Technical Service Bulletin

A14MKII – Version 3.02 Software Release

A14MKII - Auto Power Down Reliability Improvement

Location: C417

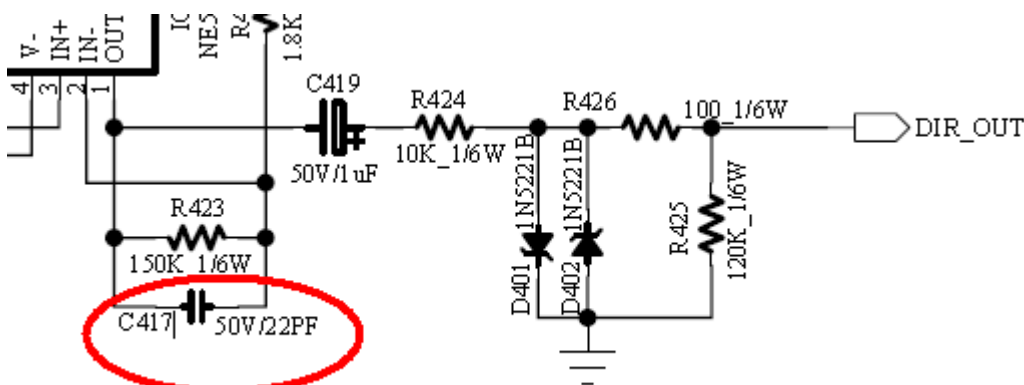
Change one a ceramic cap in associated circuit around APD detecting OP AMP from **22pF/50V** to **100pF/50V** per each model in according.

Current Part: 043TC50V220D-02 R/CERAMIC CAP **50V22PF** J3 220D 1H NPO S53C

New Part: 043TC50V101-02 R/CERAMIC CAP **50V100PF** J3 101K 1H Y5P S53C
